REVISED PLATTING BOARD AGENDA

PRELIMINARY PLAT: GRIZZLY HILLS 2 MASTER PLAN MODIFICATION
LEGAL DESCRIPTION: SEC 10, T18N, R01E, SEWARD MERIDIAN AK
PETITIONERS: SOCKEYE HOMES LLC
SURVEYOR/ENGINEER: KEYSTONE SURVEYING
ACRES: 117.17 ± PARCELS: 103
REVIEWED BY: CHRIS CURLIN CASE #: 2019-170

REQUEST: The request is to create three additional phases and extend the deadline for completion to February 14, 2029, for the approved subdivision known as GRIZZLY HILLS 2 MASTER PLAN, containing 117.17 acres +/- . The plat is located directly north of E. Dale Circle, and east of N. Covington Street, W ½ Section 10, Township 18 North, Range 01 East, Seward Meridian. In the Fishhook Community Council and in Assembly District #6.

3 PHASES AS SHOWN

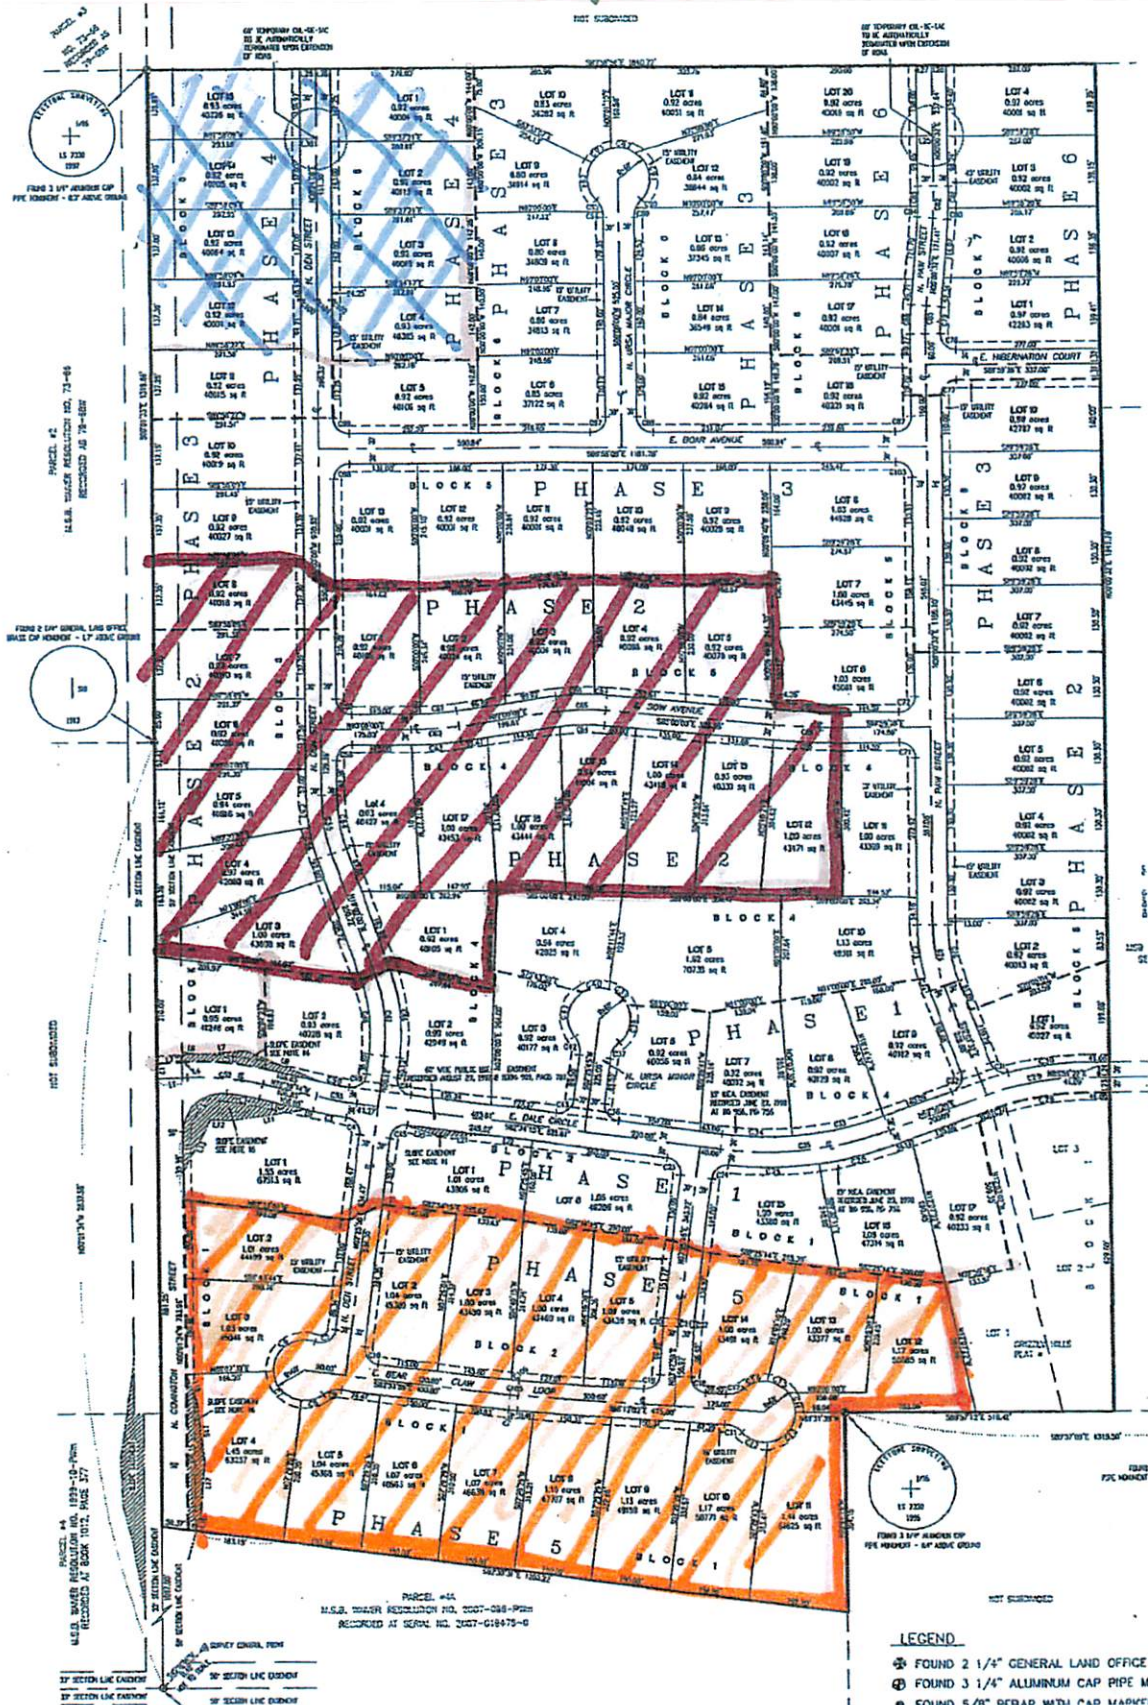
As discussed last week we would like to come back to the Platting Board under old business to add 2 additional phases. Currently we have only 1 phase left and it is not possible to complete the remainder of the approved lots in one big last phase.

We would like to make the Phases as shown on the attached. We are not adding any lots. Nothing will change except the Phases. We would also request an extension of the time for approval till February 14, 2029 to give us time to complete the phases and to retain the opportunity for the 2 administrative extensions. This will help with the lot absorption rate so we do not overly burden the project. Costs of development have risen quite a bit over the last couple years.
